# NFA Report for Potential Release Sites

0-034(a)  
0-034(b)  
73-001(b)  
73-004(c)  
73-004(d)

September 1997

LA-UR-97-3864

Fig. 1.1-1 Aerial photograph from December 1946 of PRS 0-034(a).

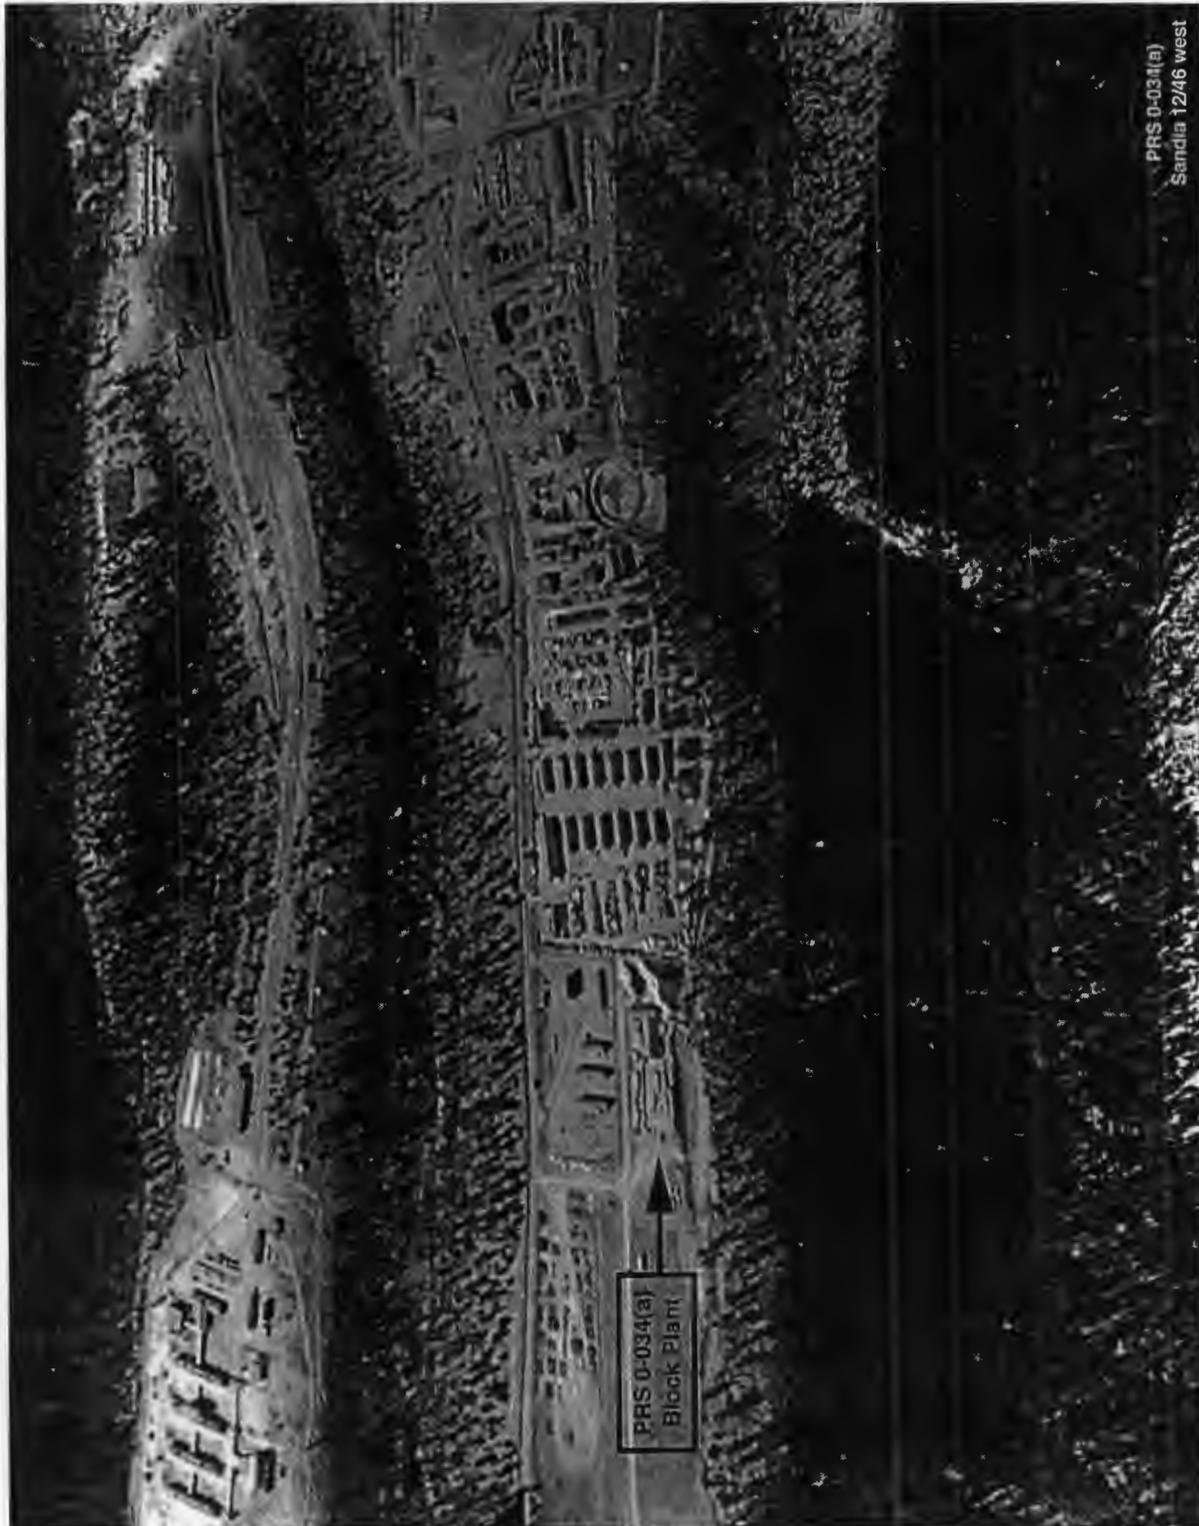
~~It would be~~  
Please draw a circle around all the concrete plant buildings.

Did outfalls from other lab buildings near concrete plant discharge in the trench area or cross the trench area?

Need 2 people familiar with site operations back then to state this site was not used for disposal of waste. What was this area (trench area) used for? Was it just a borrow area to fill in the area up gradient of it? What were the years of operation? When were the houses on Nambe Loop and Nambe Place built? ~~If this was a borrow trench~~ What were the other buildings that were on up gradient side of trench-like image? Are all these buildings immediately adjacent to up grad. of trench, part of the concrete plant? Where were the closest lab buildings?
